UNITED STATES  
NUCLEAR REGULATORY COMMISSION  
WASHINGTON, D. C. 20555

SUBJECT: PRELIMINARY REVIEW OF THE CONTAINMENT RESPONSE ANALYSES  
IN THE SHOREHAM PRA

SUBJECT: Preliminary Review of the Containment Response Analyses  
in the Shoreham PRA

FIGURE 3 - GROWTH OF CONTAINMENT UNDER 120 PSI INTERNAL PRESSURE

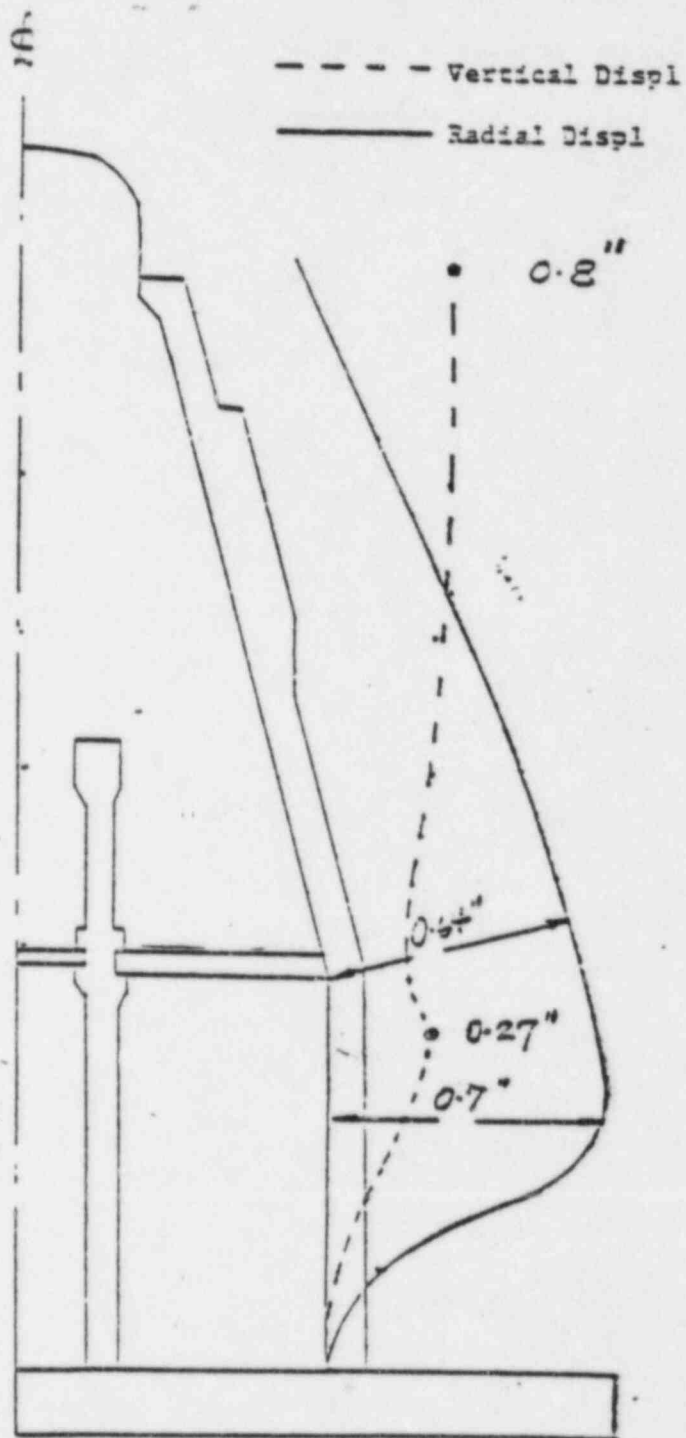
1. The diaphragm floor at elevation 62'8" of the Shoreham plant was not anchored to the containment wall as in the Limerick design. The Shoreham containment wall displacement will expand outwardly under pressure as shown in Fig. 3. Based on this free standing diaphragm floor design, the PRA suggests that the most likely leakage paths will occur at the junction of the diaphragm floor and less likely at the basemat. Under this

failure condition, the suppression pool integrity and high scrubbing efficiency will probably be maintained. However, when gross containment failure occurs, as will be the case in many Class IV accidents, the basement-containment wall juncture was judged by Stone and Webster as the most probable location to fail (Appendix M of Ref. 1). Under such failure conditions (generally defined as the  $\gamma$ " scenario), the suppression pool water will be blown out into the surrounding chambers.

Figure 4 Reactor Pedestal Schematic Showing Reactor Downcomer Geometry

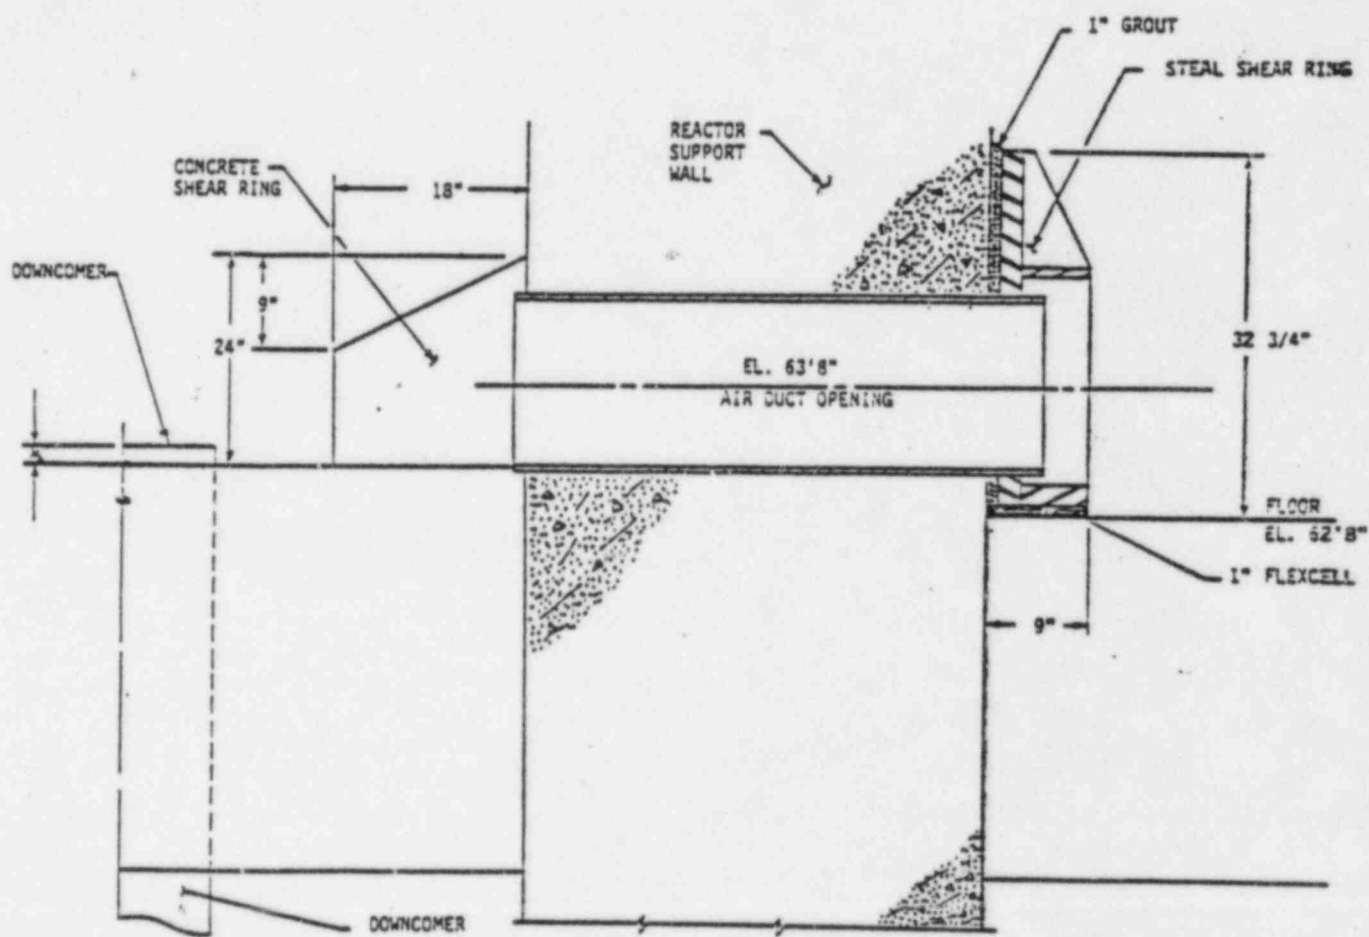
The revised geometry (see Fig. 4) of the downcomer vent pipes is intended to maximize corium flow into the pool but this also increases the potential for steam spikes and oxidation release.

1. The revised reactor pedestal geometry is not described adequately in the schematic (Fig. 4). Verify that the vent pipes and manways remain unblocked in the revised pedestal geometry.

2. Provide the estimate of the fraction of molten corium which is expected to spread out of the pedestal area through the open manways and vent pipes.
3. Verify that the downcomer vent pipes only protrude 1/2" above the diaphragm floor of the drywell as indicated in Fig. 4.
